LTR-NRC-12-47

Subject: Response to the NRC's Request for Supplemental Information on WCAP-17483-P,
"Westinghouse Methodology for Spent Fuel Pool and New Fuel Rack Criticality Safety
Analysis" (Proprietary/Non-Proprietary)

**Response to NRC Request for Supplemental Information on
WCAP-17483-NP, "Westinghouse Methodology for Spent Fuel Pool and New Fuel Rack Criticality
Safety Analysis" (Non-Proprietary)**

Figure 4-1 ENDF-VI pointwise total cross section data for Gd-155(green), Gd-157 (light green), B-10 (red), Er-166 (purple) and Er-167 (blue)

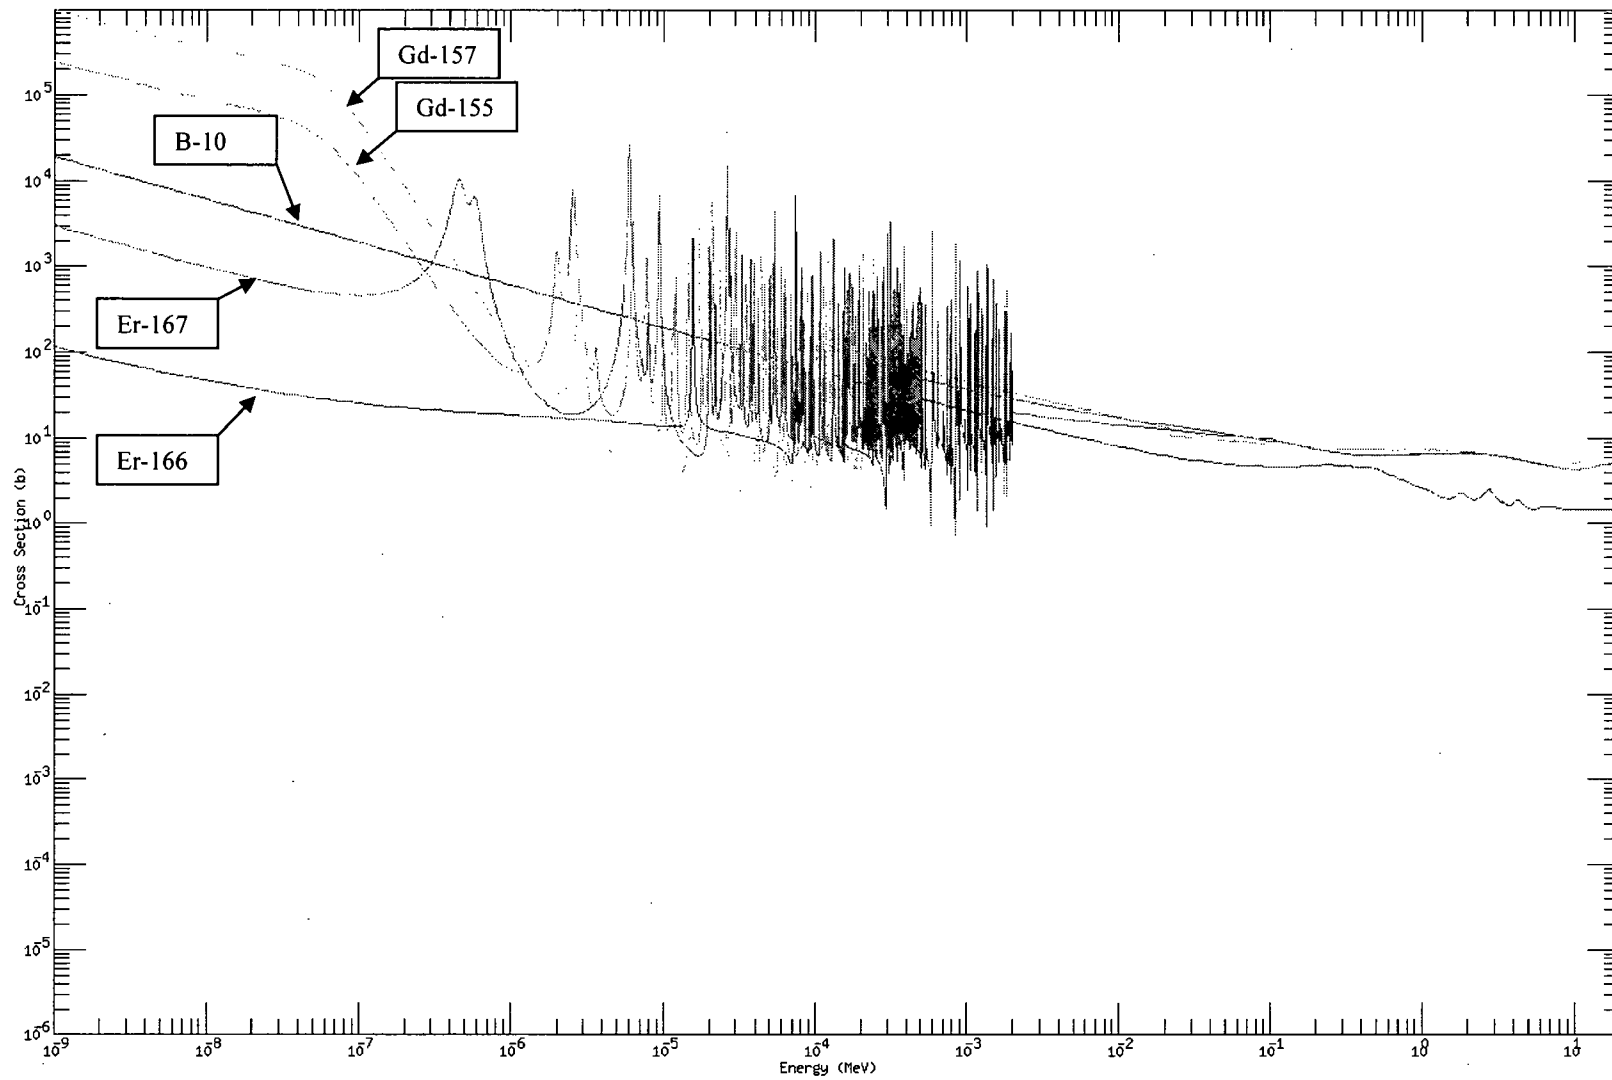
RSI Question 4. The information provided in NUREG/CR-6760, "Study of the Effect of Integral Burnable Absorbers for PWR Burnup Credit," is insufficient in of itself to draw the conclusion that it is always conservative to not model Erbium and Gadolinium as integral poisons. Additionally, besides IFBA, Erbium, and Gadolinium, NUREG/CR-6760 does not consider other potential integral neutron absorbers. Provide the analysis that demonstrates that not modeling Erbium and Gadolinium as integral poisons is always conservative, within the scope of the methodology. The NRC staff expects neutron absorbers not explicitly demonstrated within TR to be outside the scope of methodology.

Response: NUREG-6760 reviews the use of Integral Burnable Absorbers (IBAs) for their impact on reactivity and concludes:

The analyses performed in developing the NUREG-6760 conclusion involved both calculations of an infinite array of assemblies (without fixed poison panels) and cask criticality calculations which included fixed poison panels between assemblies. The IBAs included in the study which relate to this question are $\text{UO}_2\text{-Gd}_2\text{O}_3$ (gadolinia) and $\text{UO}_2\text{-Er}_2\text{O}_3$ (erbia). There were two fuel assembly types used in the gadolinia pin studies, a Siemens 17x17 fuel lattice similar to the Westinghouse 17x17 Standard design, and a CE 16x16 fuel lattice. The erbia pin studies were performed with a CE 14x14 fuel lattice.

The gadolinia study was performed using a 2 dimensional transport code, HELIOS, and included calculations in which both the number and weight percent (wt%) of the gadolinia were varied. A parametric study of the impact of ^{235}U enrichment was also performed. The results of these studies showed that for the two fuel designs, ignoring the presence of gadolinia in depletion was always conservative at all enrichments and with and without fixed poison panels considered.
